TE Connectivity

Product Change Notification: E-16-014615

General Product Description:
AMPMODU MTE HEADERS GPL 296

Change in circuit cavity features

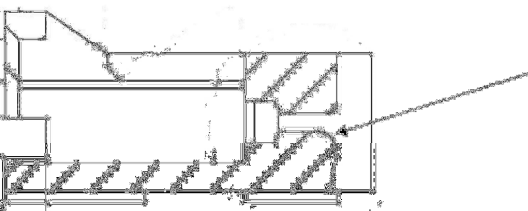
Description of Changes
To satisfy customer demand for the capability of MTE headers to handle RoHS solder temperatures, TE Connectivity has retooled the MTE header product line to use high temperature compatible LCP molding material. These changes will result in the following product changes: 1) Housing material will change from high temperature nylon to LCP. 2) The header housing width will be reduced by 0.005 inches to accommodate the assembly process. 3) In order to consolidate some housing features, the contact cavity configuration will be changed slightly as shown in the attached sketch.
